ORIGINATION FORM

Proposed Revisions to a Standard Plans Index
(Please provide all information – Incomplete forms will be returned)

Index Number: **639-001**
Sheet Number (s): 2
Index Title: Service Point Details

SERVICE POINT DETAILS

TYPICAL DISTRIBUTION POINT SCHEMATIC DETAIL

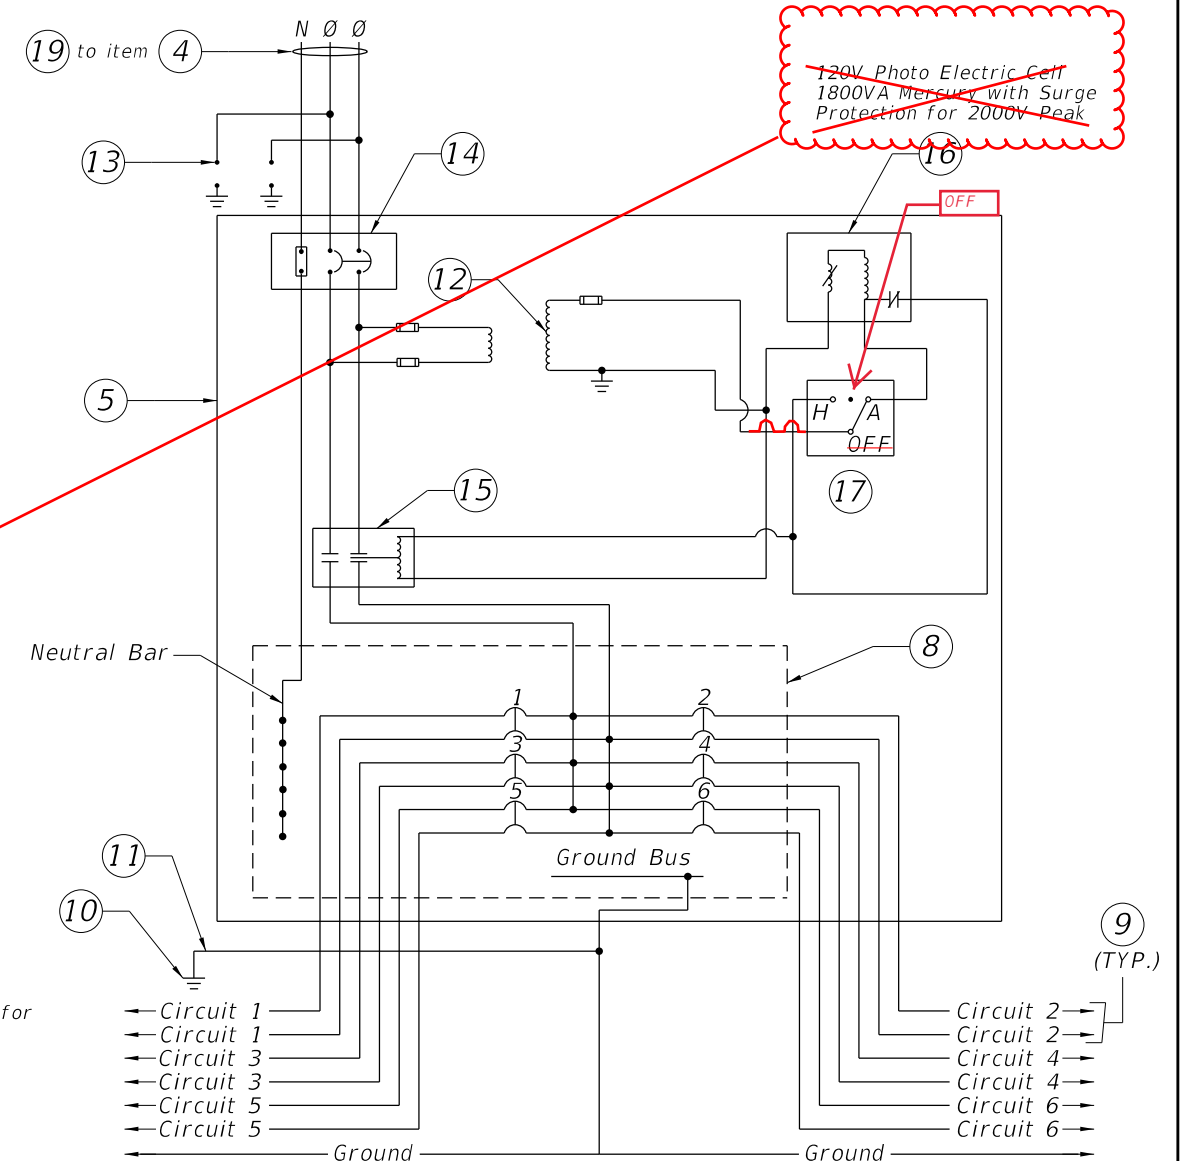
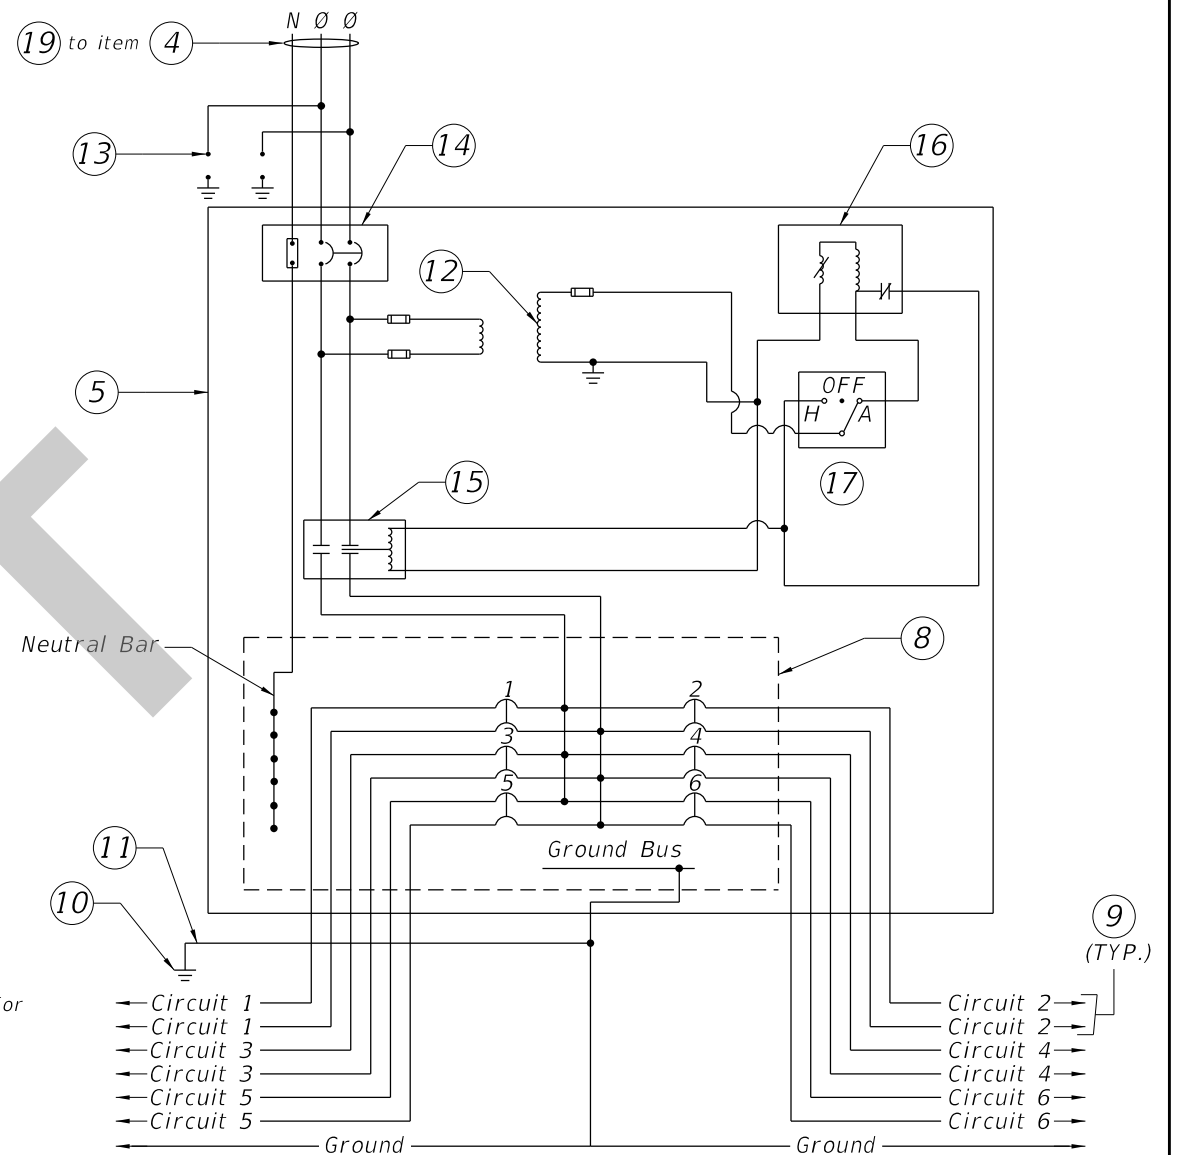
1. In the top right of the Typical Distribution Point Schematic Detail is a symbol for an HOA switch (Hand-Off-Automatic). The "off" text is shown at the connection of the hot lead, should be above the off position.
2. Same detail has annotation stating "120V Photo Electric Cell ... Mercury with Surge Protection for 2000V Peak. The text should read "120V Photoelectric cell, 1800VA with 2000V Peak Surge Protection."

1. Just a scrivener's error.
2. A scouring of the inventory of most major electrical manufacturers and suppliers revealed no "mercury photo electric cells". I also went back through approved shop drawings for the past several years and noted no approved photoelectric cells mentioning mercury as a component.

Corrected and moved to the Notes.

~~120V Photo Electric Cell
1800VA Mercury with Surge
Protection for 2000V Peak~~

14. Lighting Control Panel Main Breaker.
15. 2 Pole Electrical Lighting Contactor.
16. 120V Photoelectric cell, 1800VA with 2000V Peak Surge Protection.
17. Hand-off Automatic Selector Switch (Part of Lighting Contactor, Shown Outside for Clarity).
